**APPELLANTS' EXPERT REPORT VOLUME 1**

**Re: Dell Drain Outlet Report – Tribunal File 007Dell21**

The objective of this report is to review and comment on the assessment schedule in the Dell Drain Outlet report dated November 26, 2020 (2020 Report) prepared by Mark D. Hernandez PEng, Dillon Consulting (the Engineer).

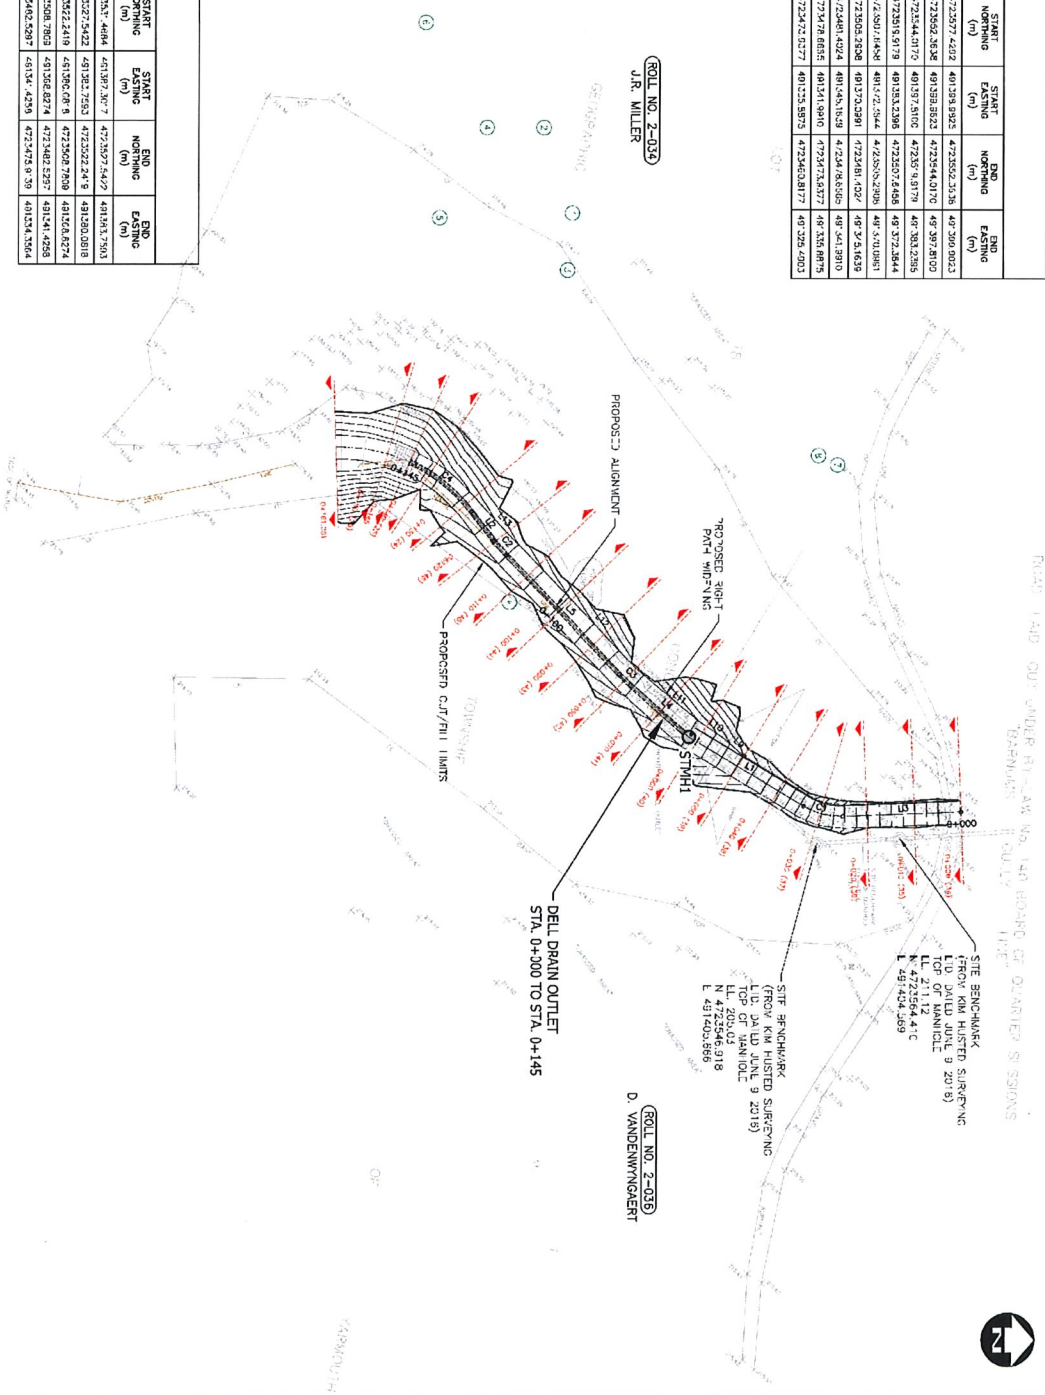
Drawing 2 of 5 notes a "pile of rubbish" at station 0+100.

Based on my site examination I determined that the "pile of rubbish" is a large quantity of automotive tires – see page 7 of my photo log in Appendix C.
